RE: APD SE Area Command Center Project – Narrative

DRB Project Number: 1003450 Hearing Date: Feb 3, 2016  
 Project: 800 Louisiana Agenda Item No: (1)

SUBJECT: Site Plan for Building Permit

**Subject:** Project # 1003450, Case # 15EPC-40029 – APD SE Area Command

**C4 DETAIL**  
S #4

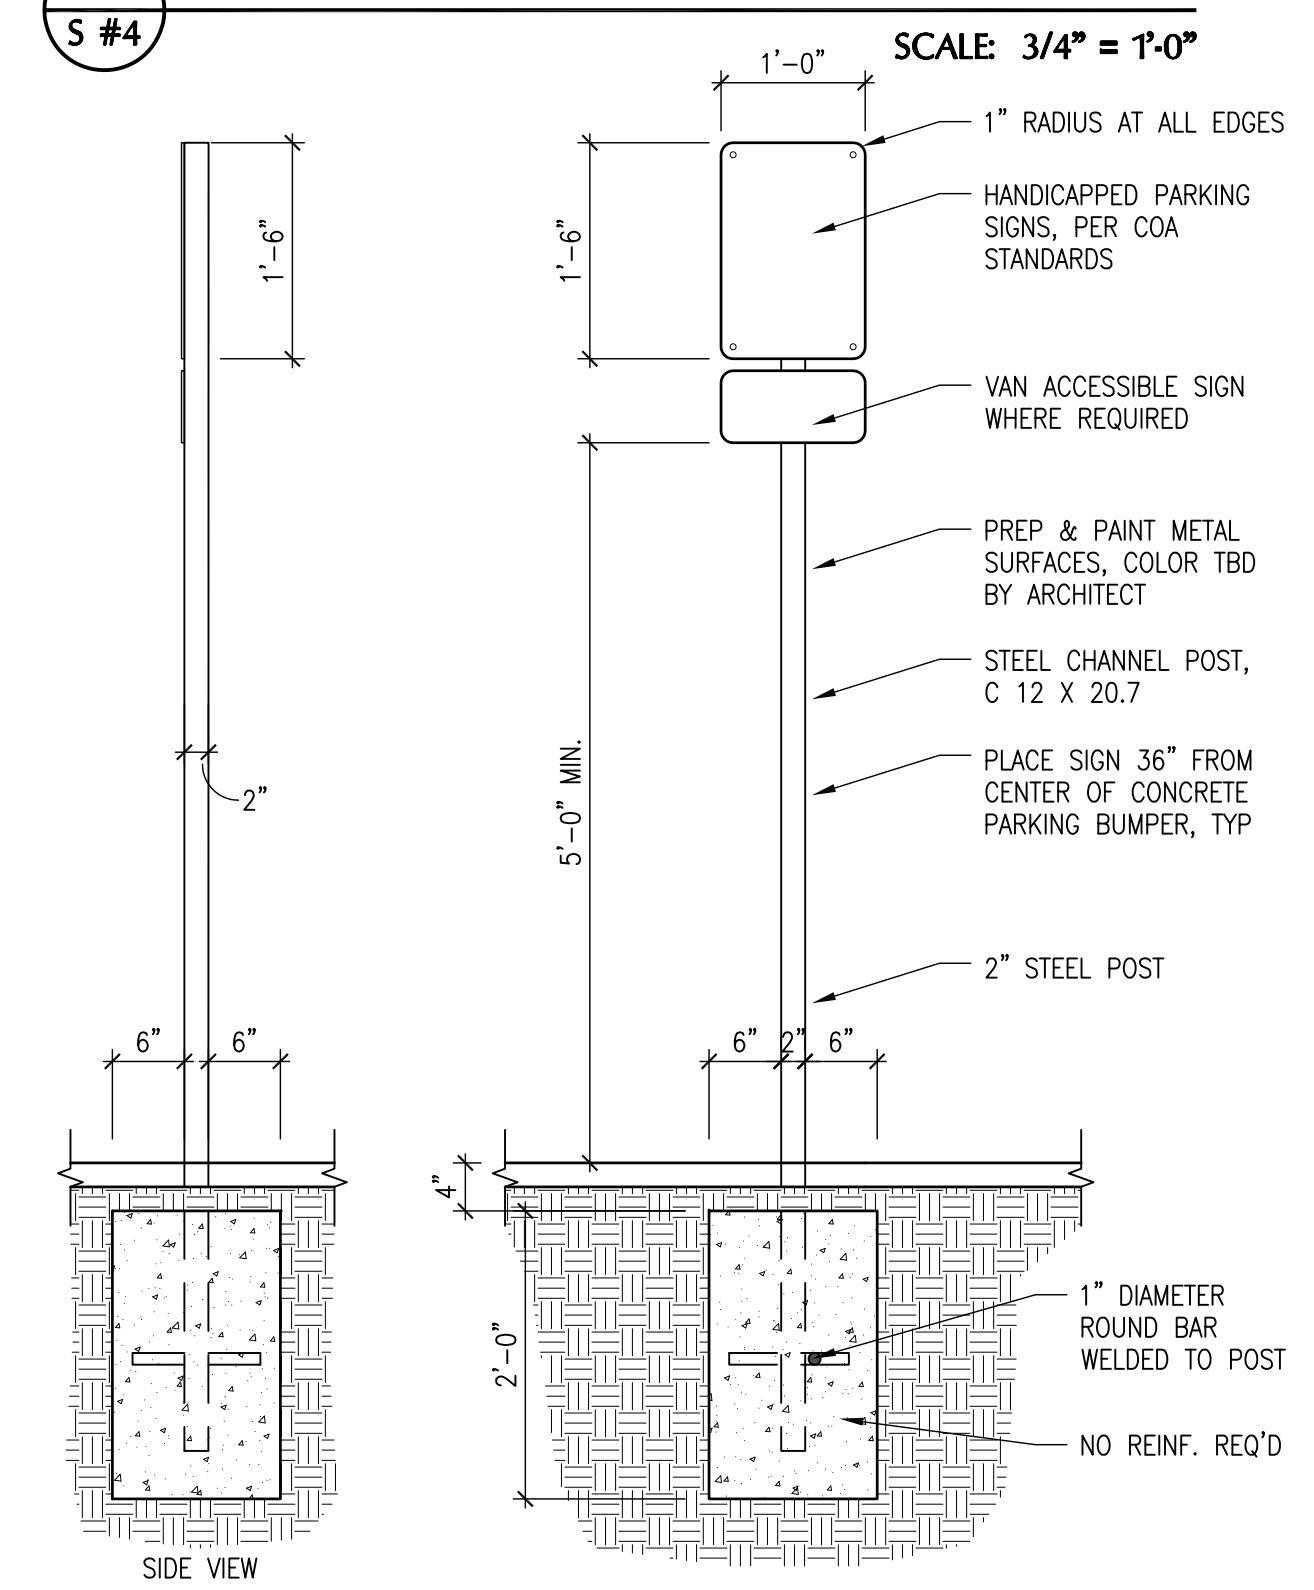
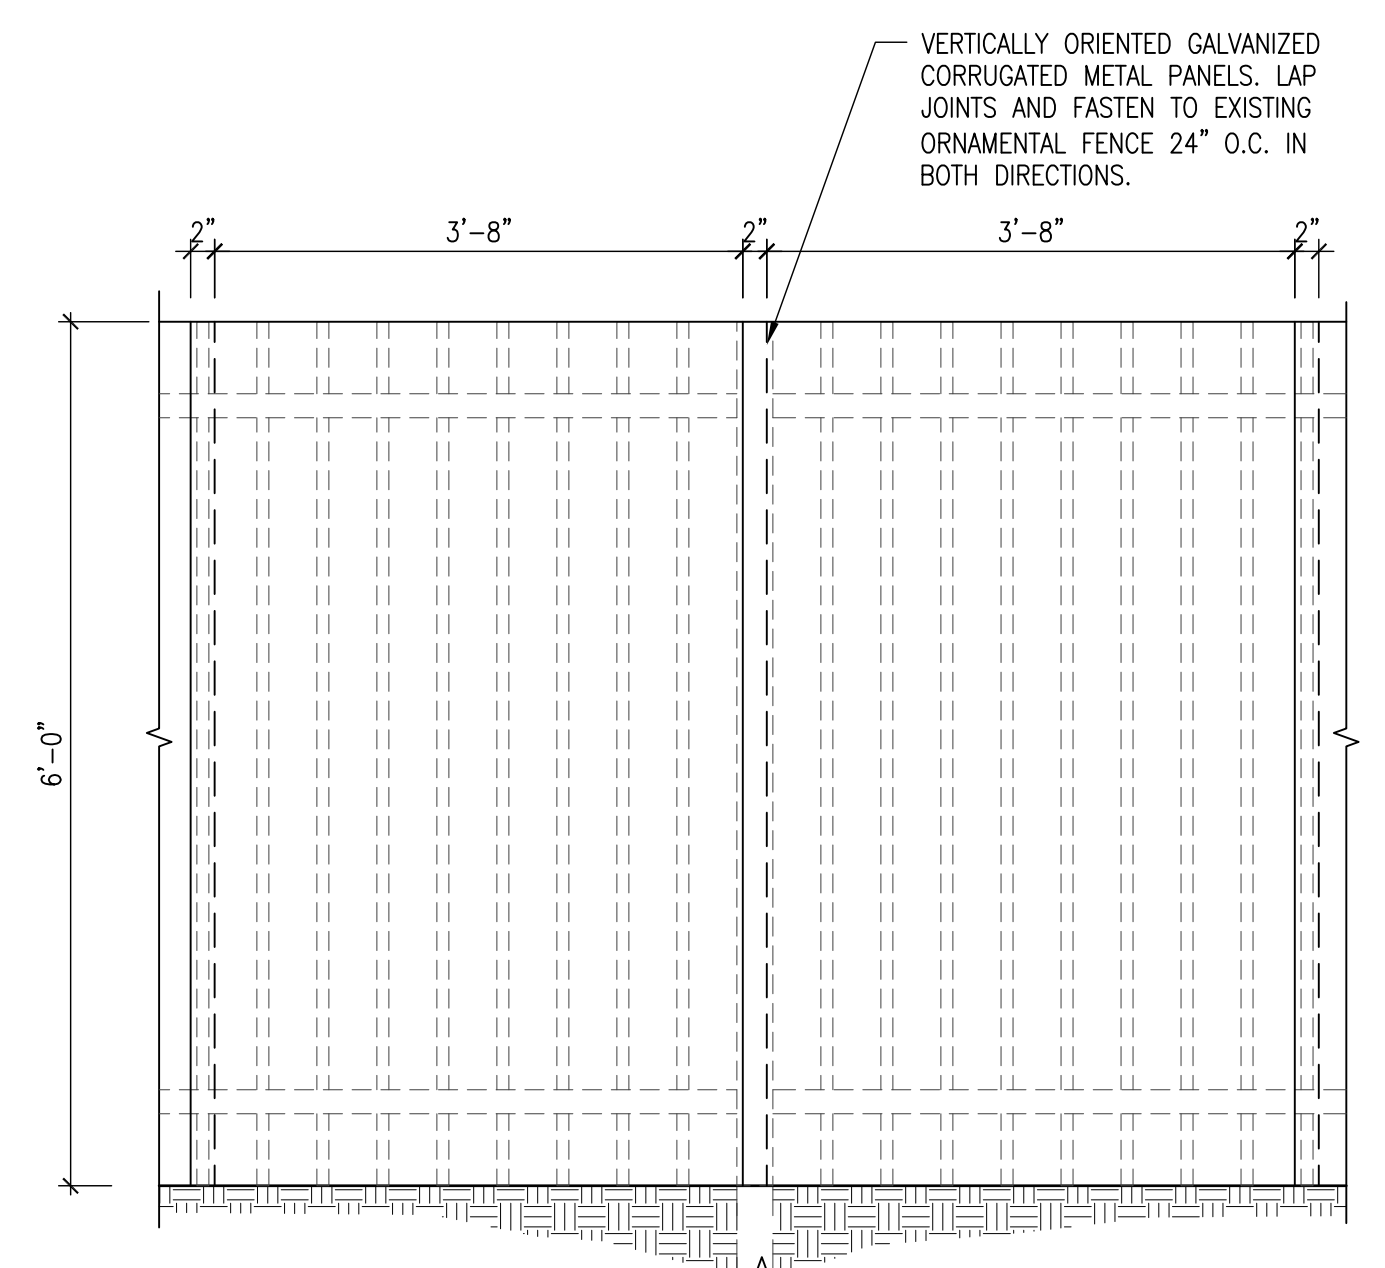
2. The ADA accessible parking sign must have the required language per 66-7-352.4C NMSA 1978 **"Violators Are Subject to a Fine and/or Towing."** Please show detail of ADA signs. **The required language is met and the details are shown on Sheet #4.**

4. Please detail ADA ramps from public right-of-way and proposed ADA ramps into modular building. **ADA ramps are called out on Sheet #1 and details are shown on Sheet #4.**
